NORTHERN BEACHES LOCAL PLANNING PANEL

WEDNESDAY 14 DECEMBER 2022

Agenda for the Northern Beaches Local Planning Panel to be held on Wednesday 14 December 2022

Figure 2 NBC Flood Hazard Map

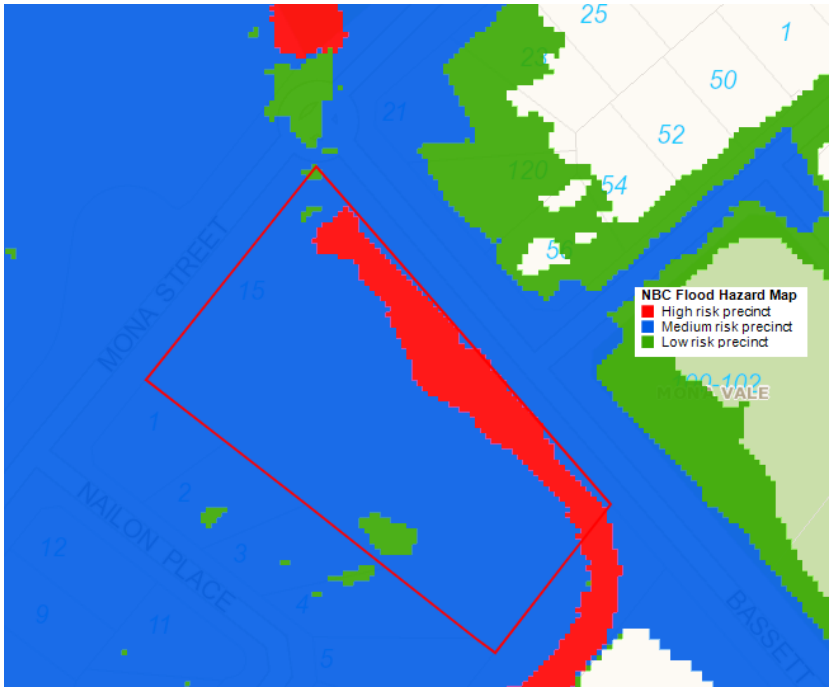
The site is also within the Flood Planning Area. Council's Flood Hazard Map identifies High, Medium and Low Risk Precinct areas within the site (see Figure 2). The site is also identified in the Pittwater Estuary Mapping of Sea Level Rise Impacts Study (2015), as being impacted by estuarine wave action and tidal inundation coastal inundation.

Figure 10 – 800m Centre Investigation Area and site constraints mapping (Source: Northern Beaches Local Housing Strategy)

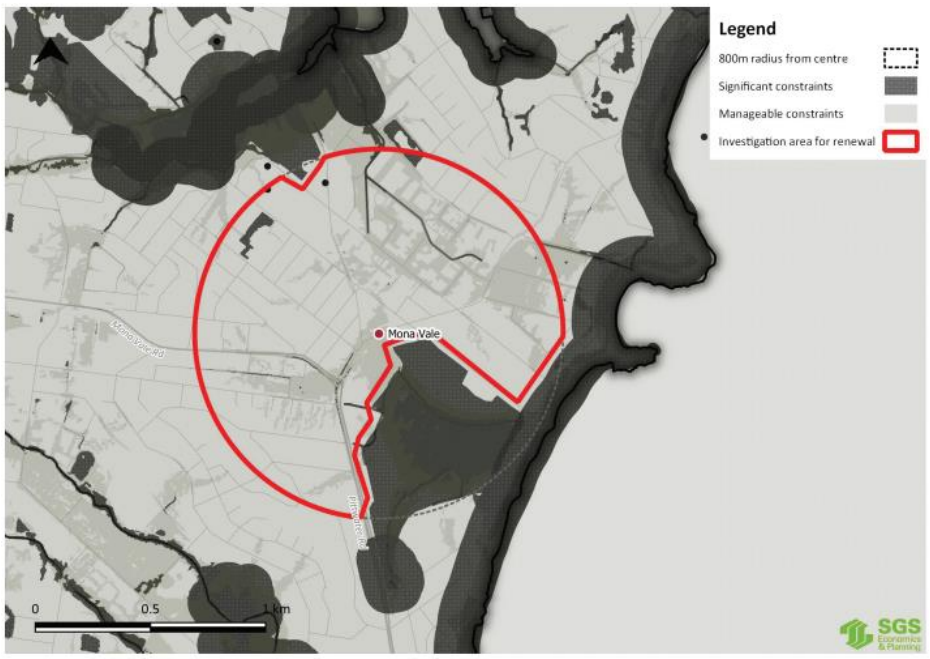
The Planning Proposal is also incorrect to state that the area proposed for housing is within the 800m radius Centre Investigation Area for Mona Vale, or that the site has not been previously considered. The site is not within the Centre Investigation Area and has been specifically identified as being heavily constrained in the Local Housing Strategy as indicated in the following image from the Local Housing Strategy

Figure 3: Working plan showing a 6.5m "rear setback" being applied to the western and southern boundaries (indicated in red).

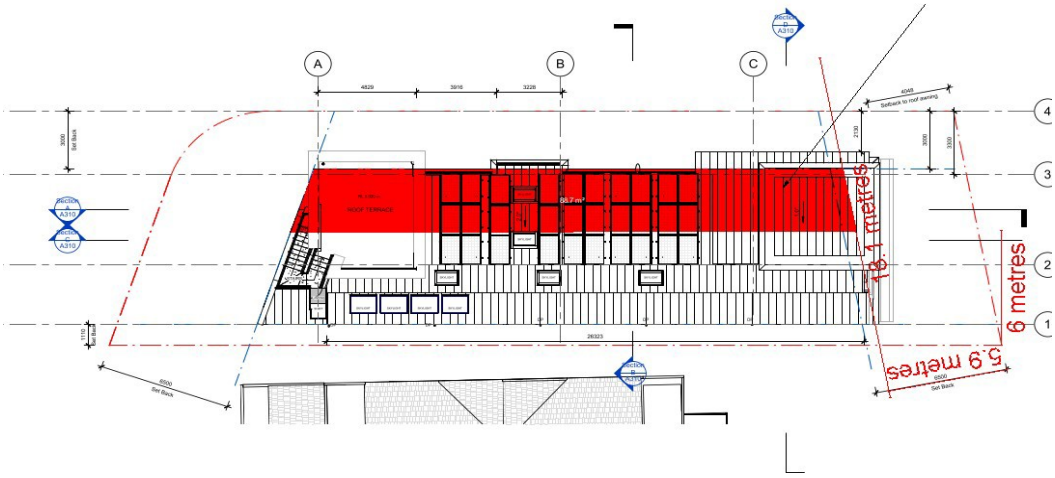
'rear' boundaries, thereby requiring a 6.5m setback, and have also suggested that, as the objectives applying to a secondary street frontage under the P21DCP have not been met, that the 6.5m setback control (instead of 3.25m) should be applied to Nabilla Road. This is however impractical and unreasonable, given the site area. The site has a depth of 12.46m and therefore, the strick application for two x 6.5m setbacks would render development of the site virtually impossible, or simply that significant variations would need to be granted to allow a reasonable scale of development. Imposing 6.5m to all sides except for the northern Nabilla Road setback (if it is left at 3.25m) equates to a maximum buildable area of 88sqm, or 18% of the site area. This is significantly less than any other buildings on Iluka Road or Nabilla Road. Such an example is demonstrated on the below working drawing prepared by the author of this report.

Figure 8: Working Plan/Survey (north/ Nabilla Road is at top of image)

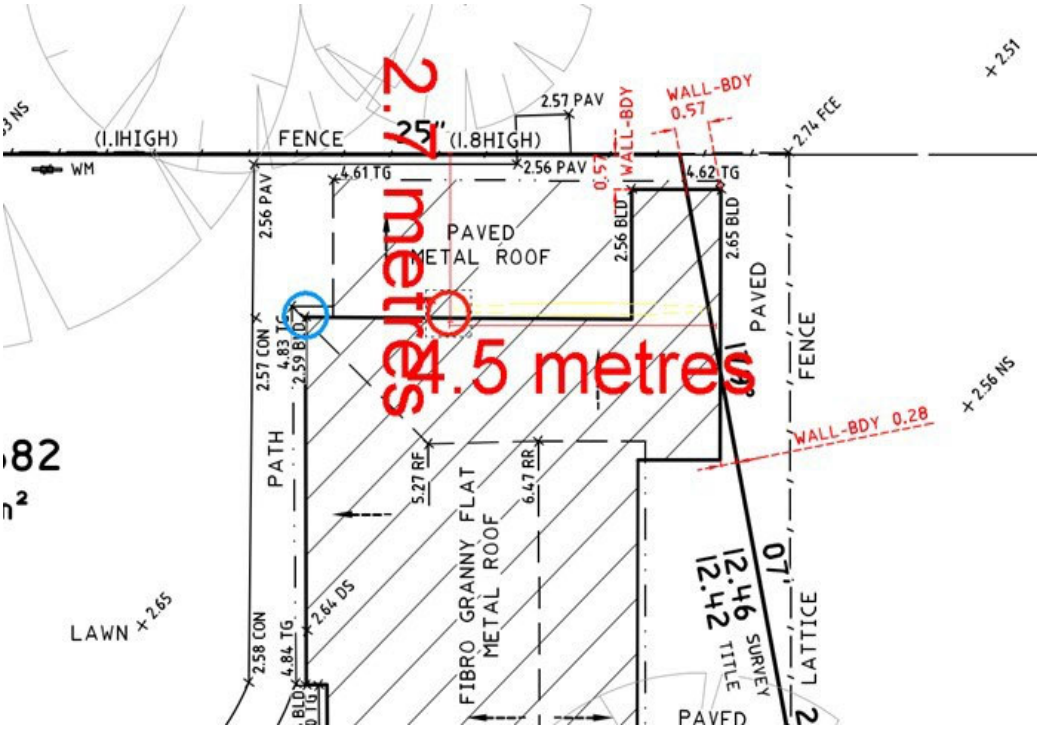
In relation to the photograph above, note that the blue-circle corresponds with the blue circle on the below working plan (derived from the Applicant's Survey Plan).

Figure 9: Working Plan (extract of plans)

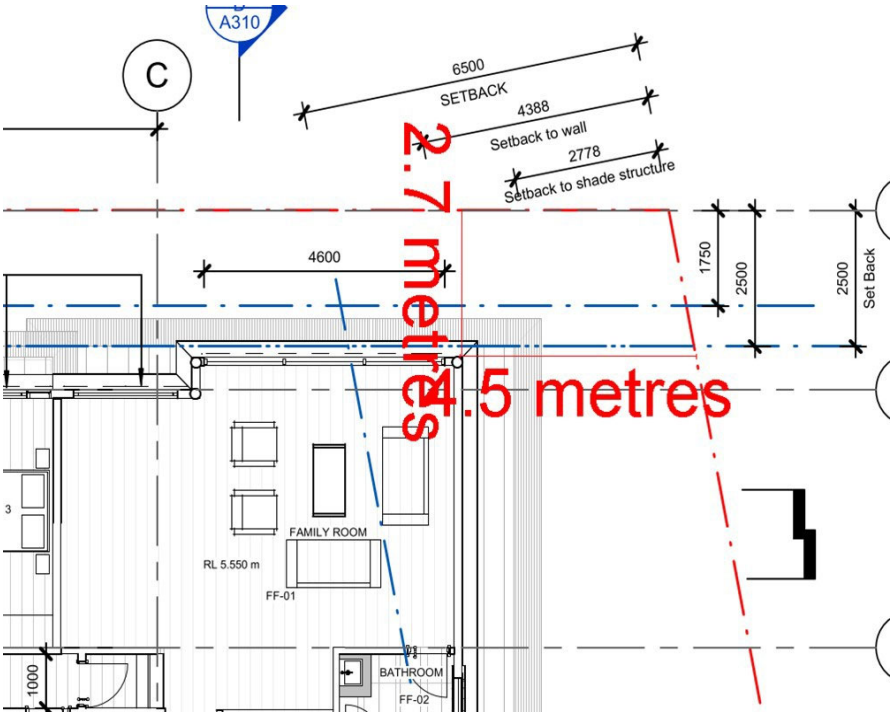
In relation to the figure above, the blue circle corresponds to blue circle on the photograph preceding. The red circle (at the intersection of the 2.7m and 4.5m proposed setback line) corresponds with the north-easternmost corner of the proposed dwelling, at first floor level, as annotated on the below figure which is an extract of the plans.

Figure 10: Elevation Plan - showing setback of first floor being 2.5 metres with eaves between 1.5m and 1.8 metres from street at Nabilla Road.

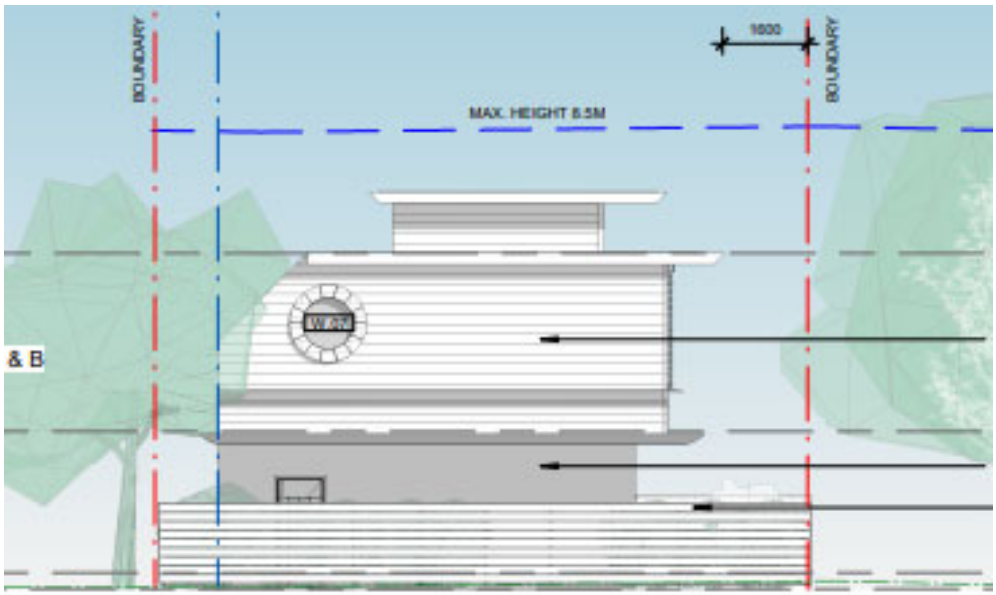
As described earlier in this report, under the planning controls contained in the P 21 DCP for corner lots, it is not considered realistic to expect a building to be able to achieve full compliance with the setback controls of 6.5 metres.

Figure 11: Plan - showing portions of building within the secondary front setback area

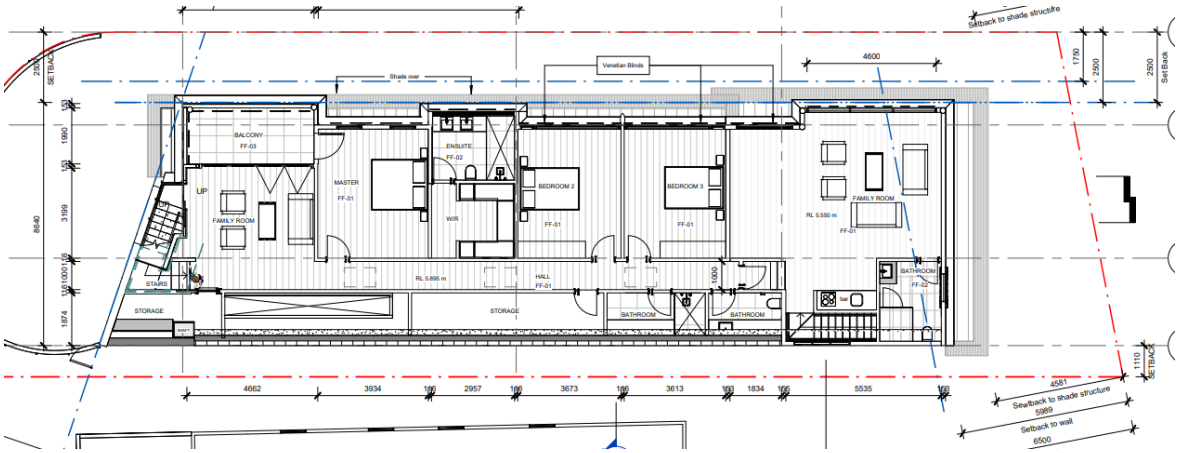
The proposal breaches the prescribed front setback controls, with a swimming pool which is 2.0m from the Iluka Road frontage and the portions of the first floor at 2.5m and roof overhang at 2.2m from the Nabilla Road frontage.

Figure 1. *Building height non-compliance*

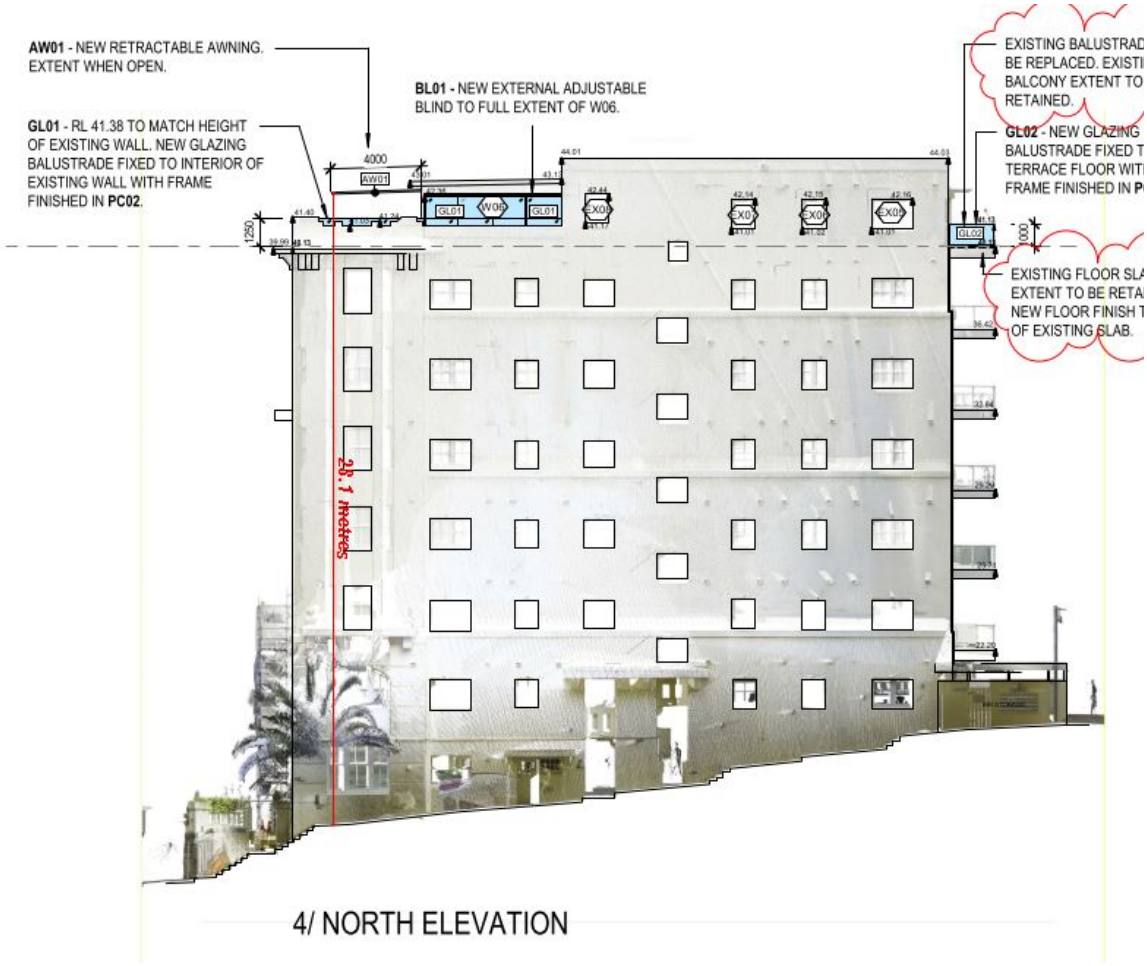
Development standard:	Height of buildings
Requirement:	11m
Proposed:	28.1m
Percentage variation to requirement:	155.4%
